155 EAST 37TH AVENUE (COMPLETE APPLICATION)
DE416511 - ZONE RM-3A

DEVELOPMENT PERMIT STAFF COMMITTEE MEMBERS

DEVELOPMENT PERMIT STAFF COMMITTEE RECOMMENDATION: APPROVE

PROPOSED 5TH LEVEL
 SCALE: 1/8" = 1'-0"

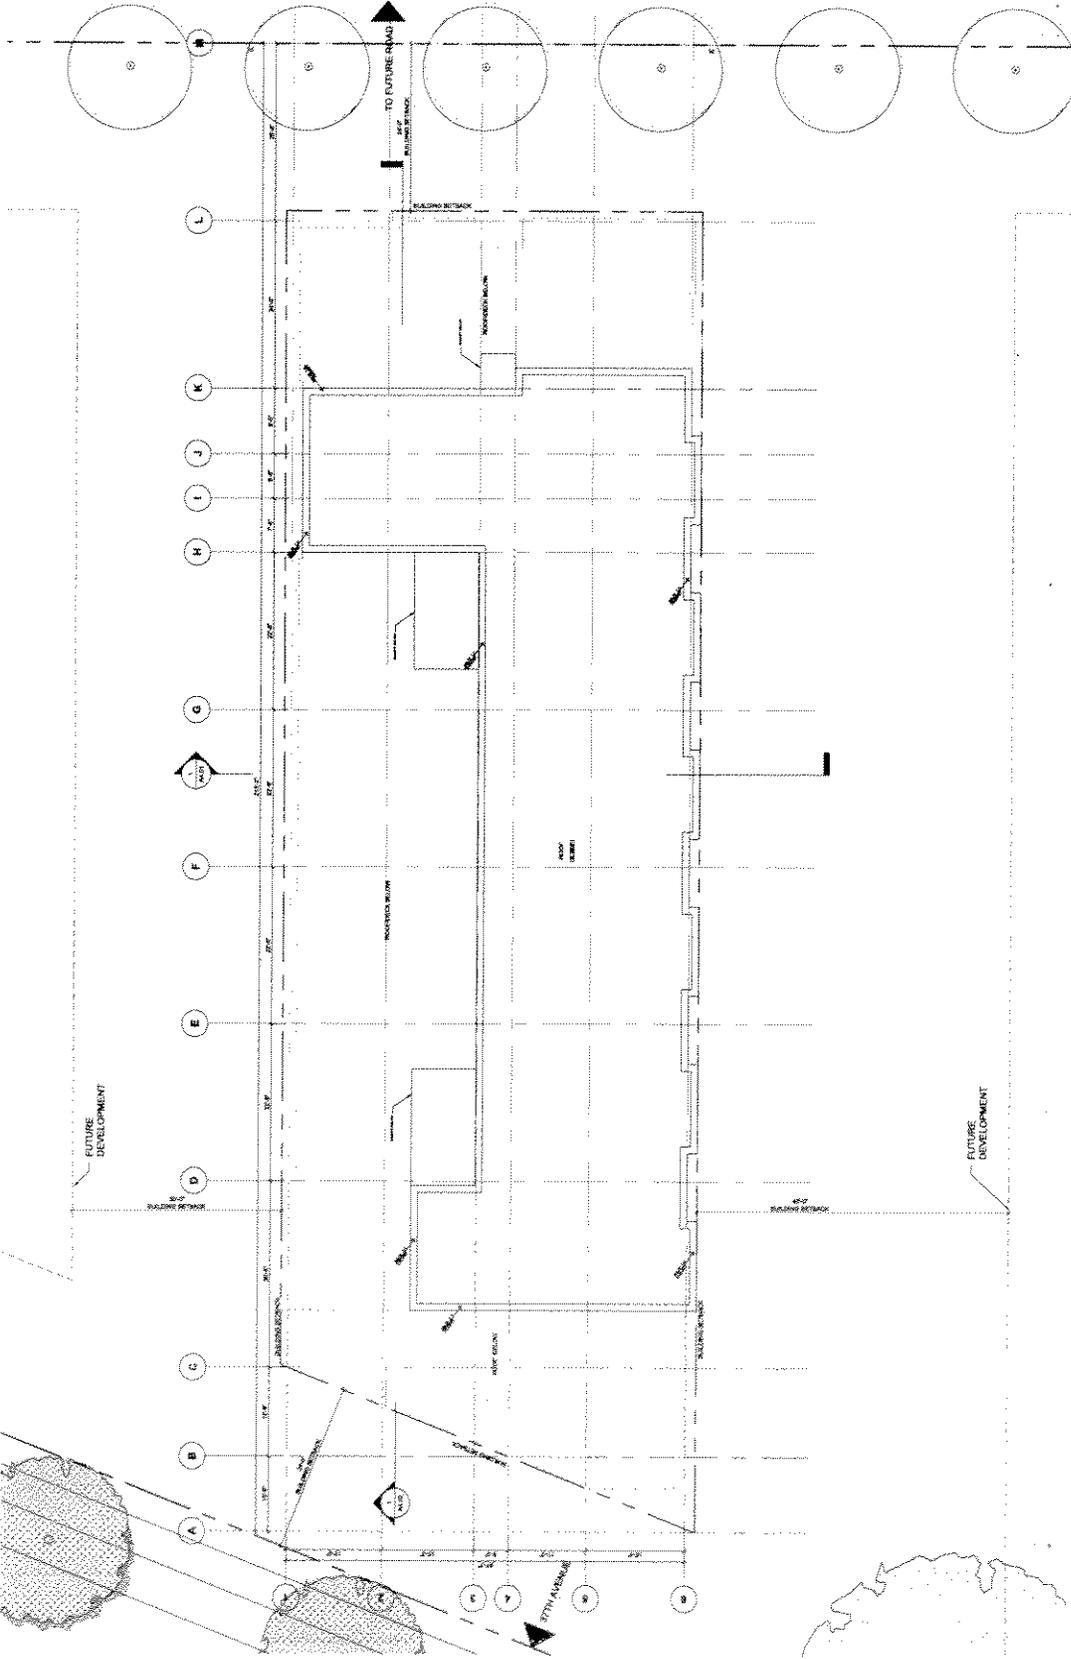
- 1.5 design development to the fifth level roof terrace to accommodate a variety of uses and to consolidate and enlarge planters to be located to one side of the space so that other programmed uses may be incorporated;

Note to Applicant: Consideration should be given to concentrating urban agriculture uses to enable other areas to be available for resident activities and gatherings. Consideration should be given to relocating the residents' barbeque facility to this semi-private location to enjoy the evening sun.

Landscape Plan -
5th Level Roof Deck

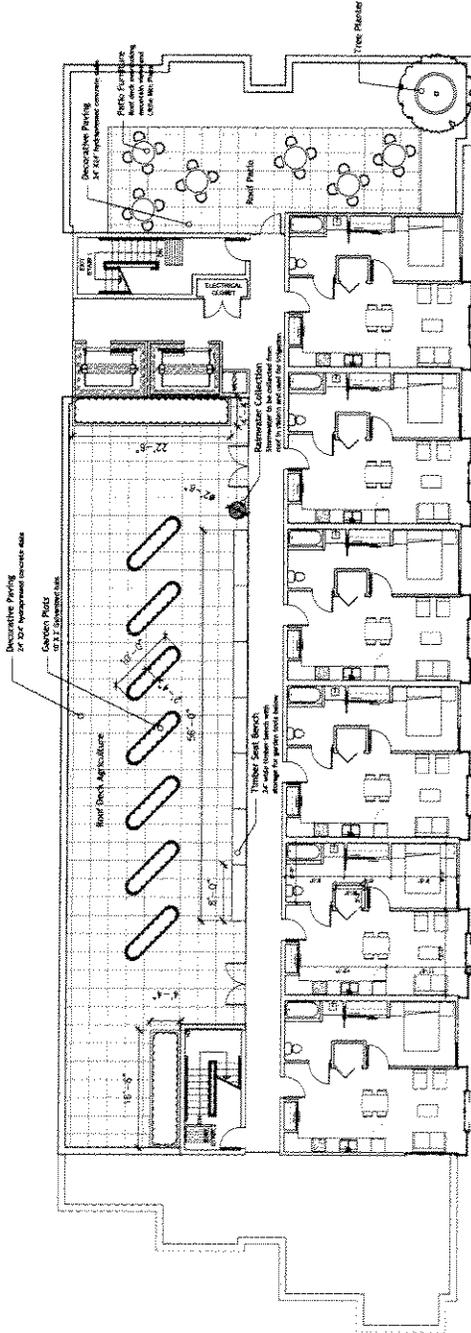
A.1.18 provision of a large scale detailed landscape/planting plan(s) for upper level urban agriculture areas;

Note to Applicant: Further design development and programming to include starter plant list, work station, compost, irrigation, benches, any vertical landscaping and additional fruit trees and/or structures. Provide a detailed section through the garden plot area to indicate materials, grading, soil depth and function.
